THE BRIDGES - GROVE CABINS PH1 & MOUNTAINSIDE PH 2

CONSTRUCTION DOCUMENTS

EDEN, WEBER , UTAH

GP1

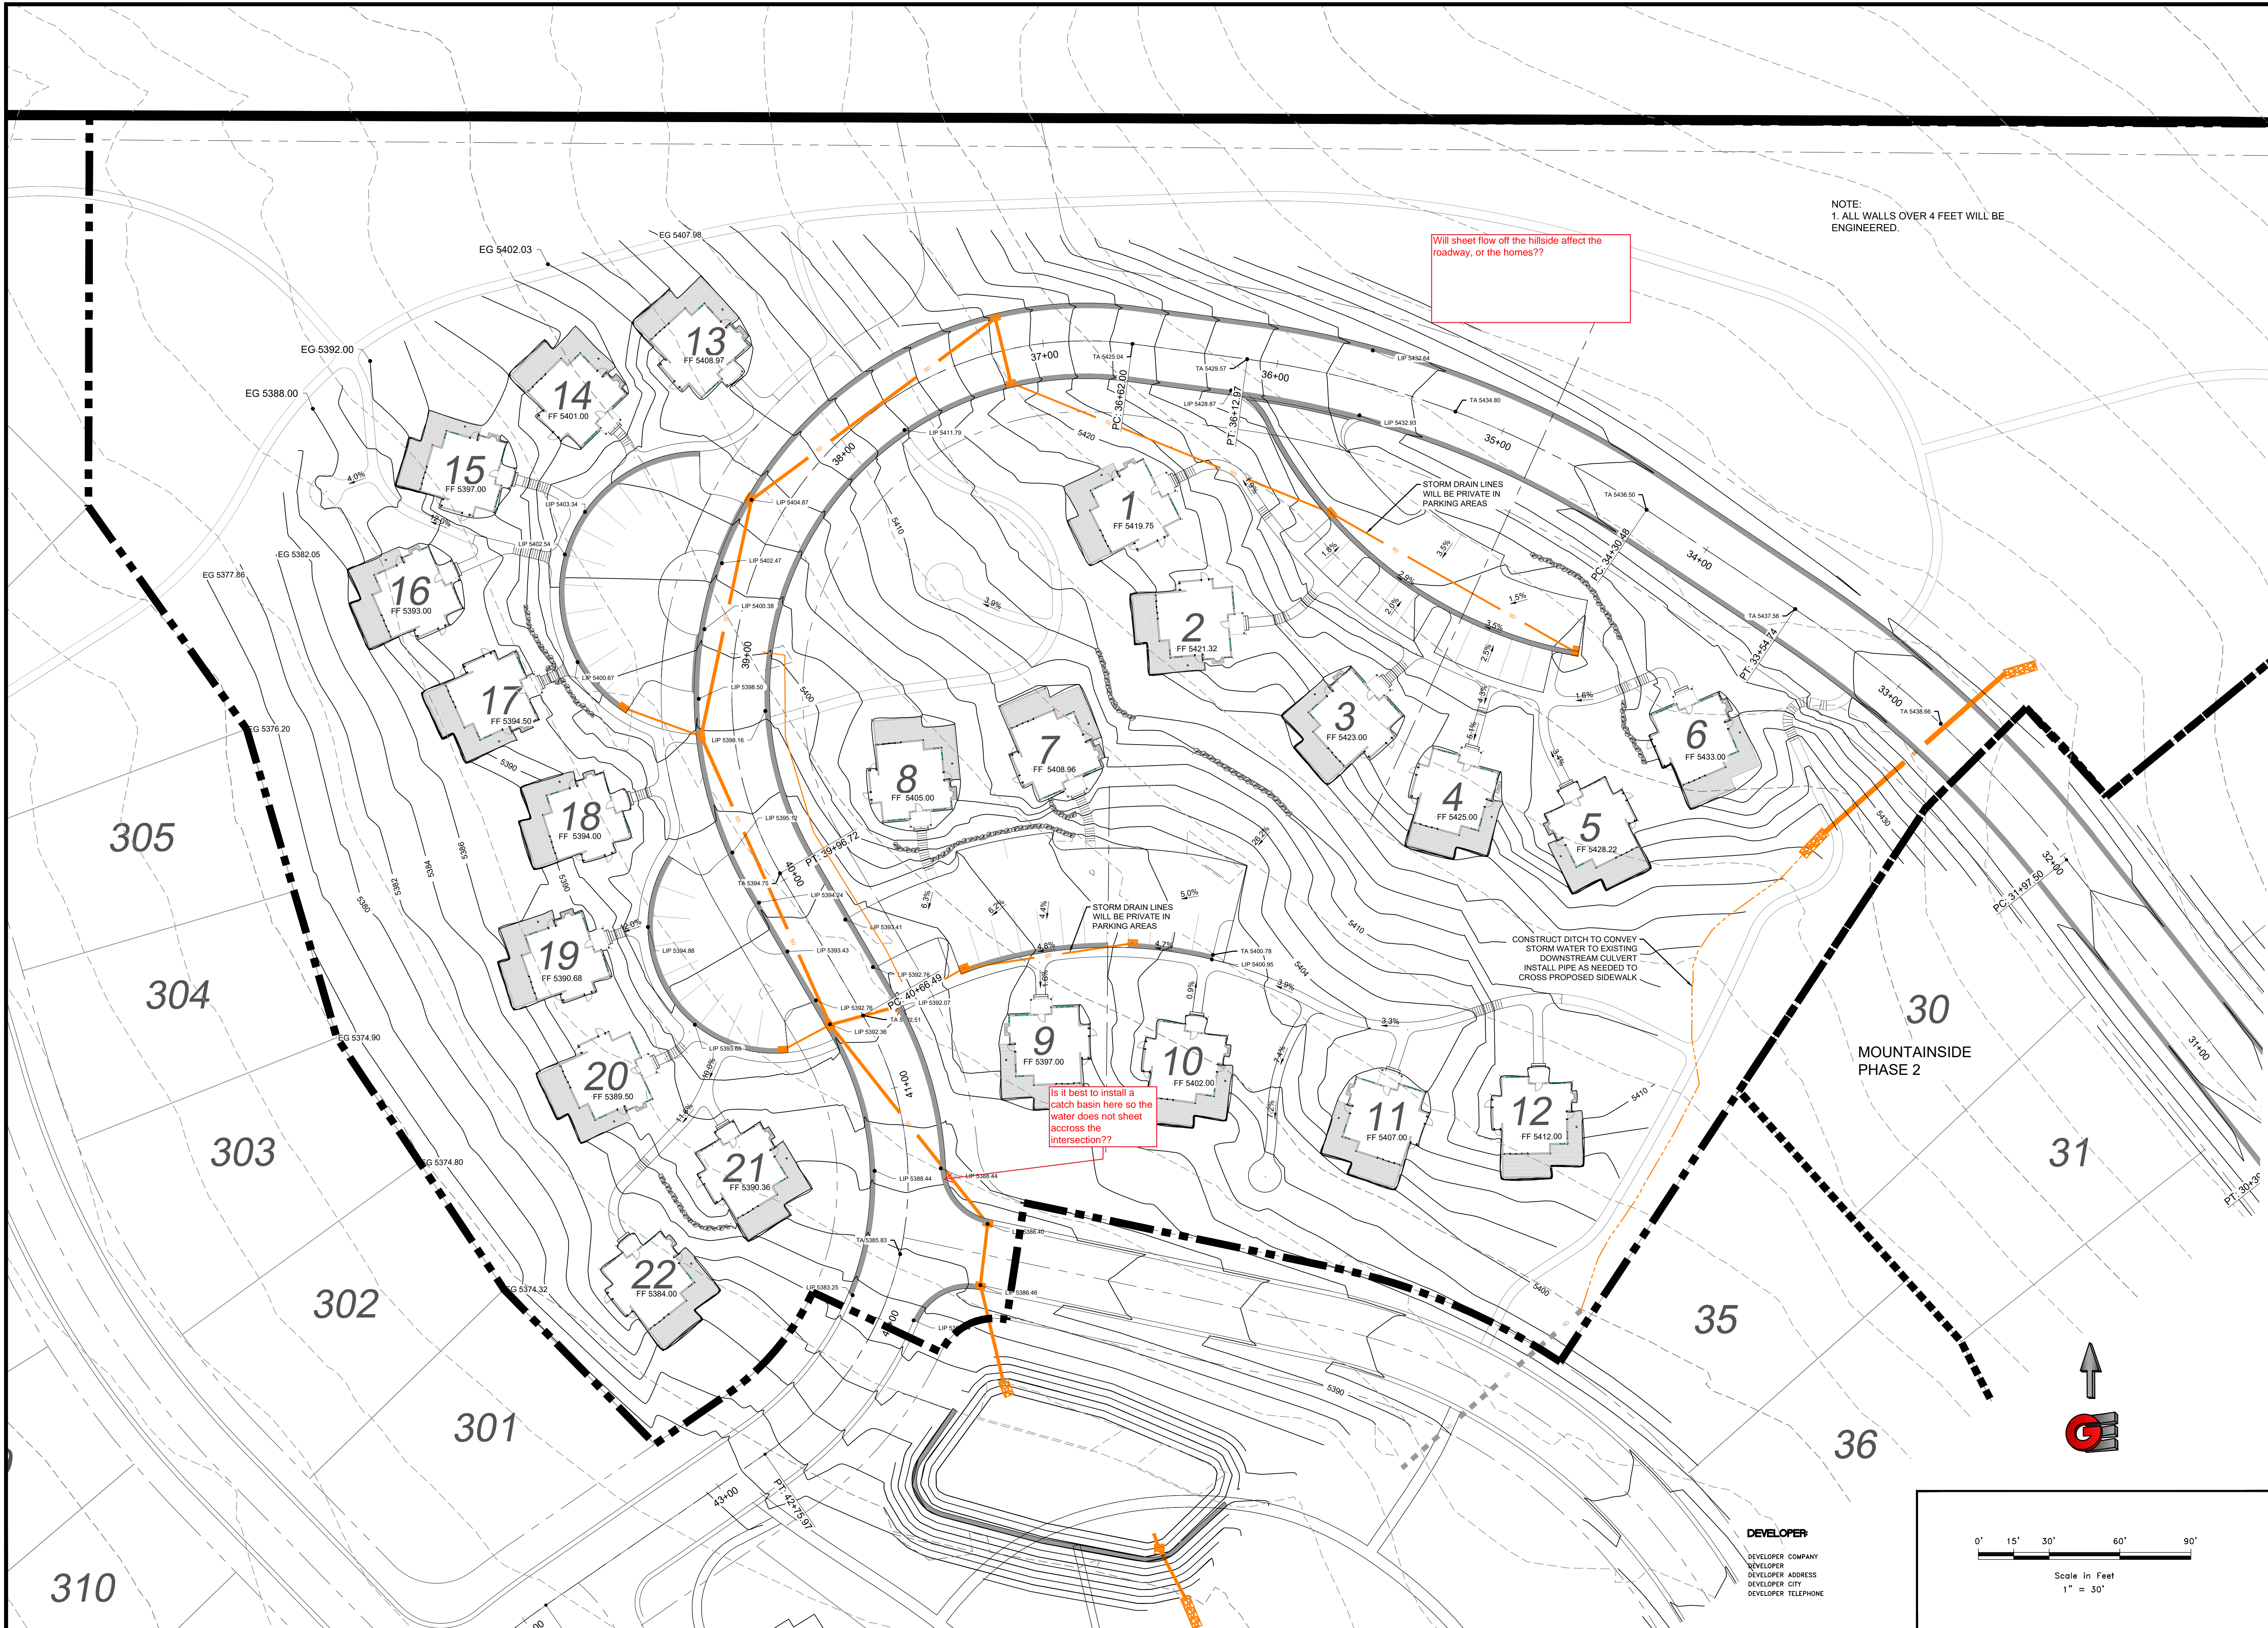
Will sheet flow off the hillside affect the roadway, or the homes??

Is it best to install a catch basin here so the water does not sheet across the intersection??

GP1B

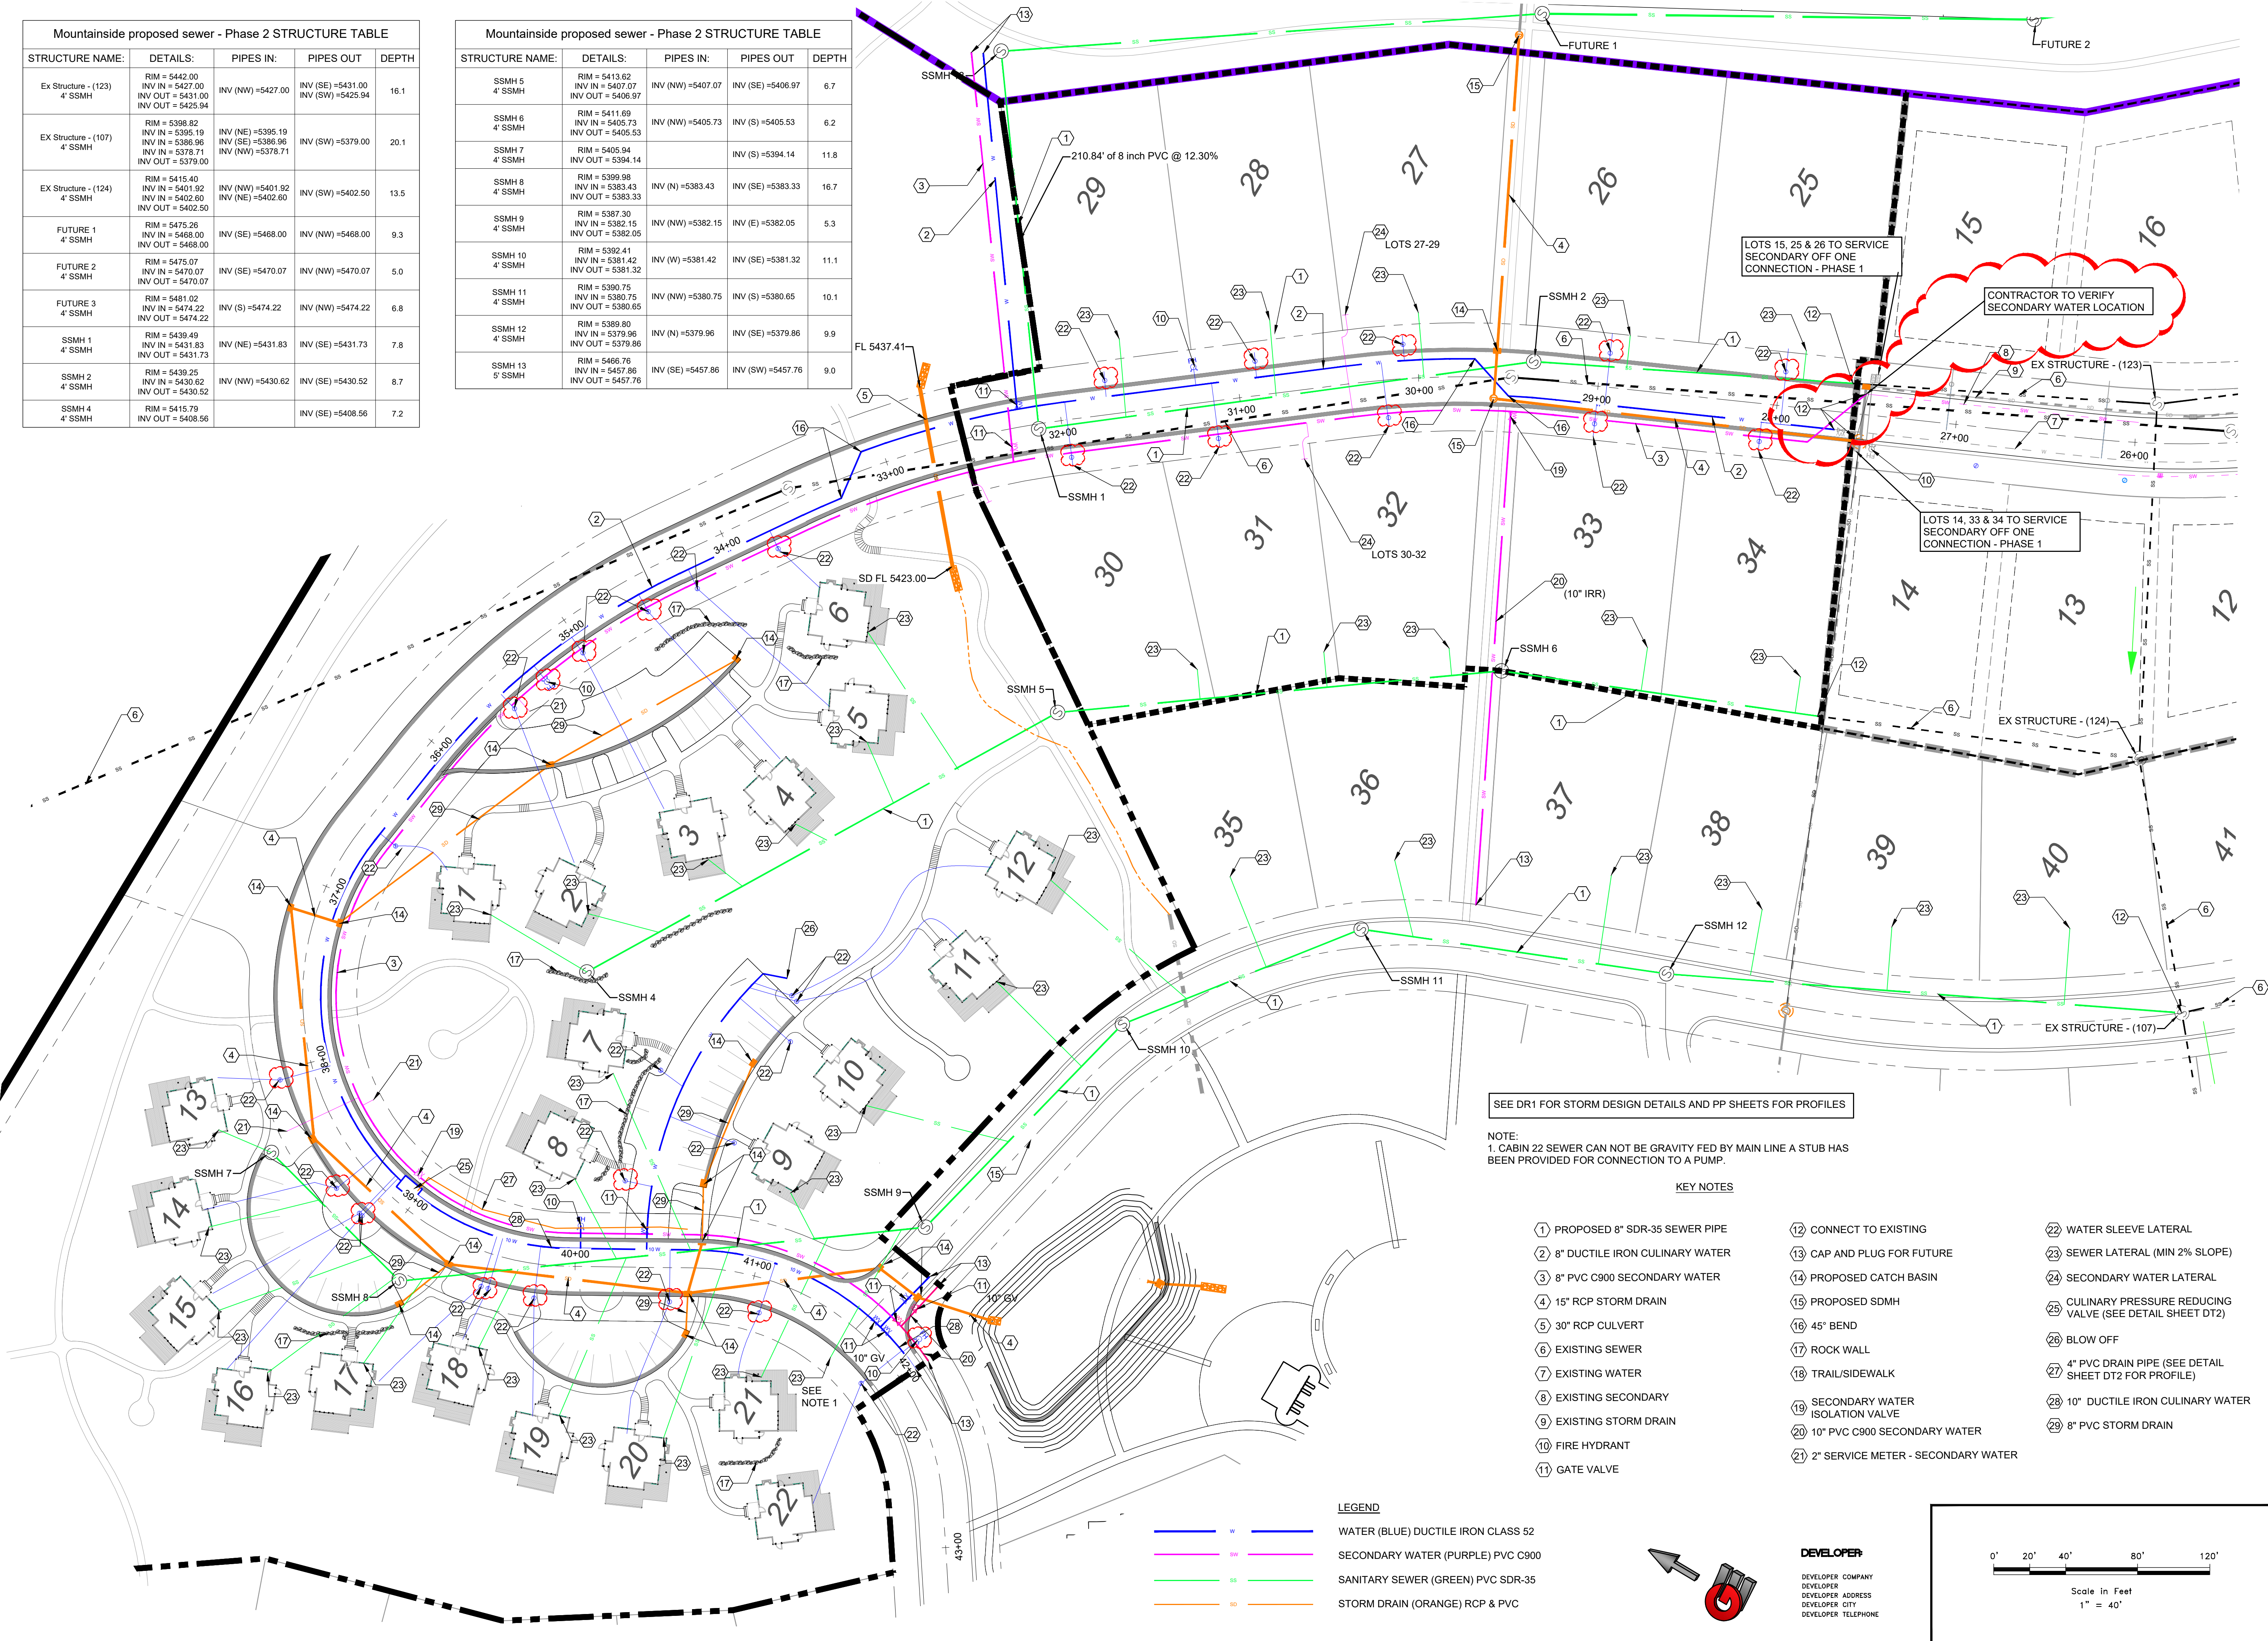
want to make sure that the water will not sheet across the intersection
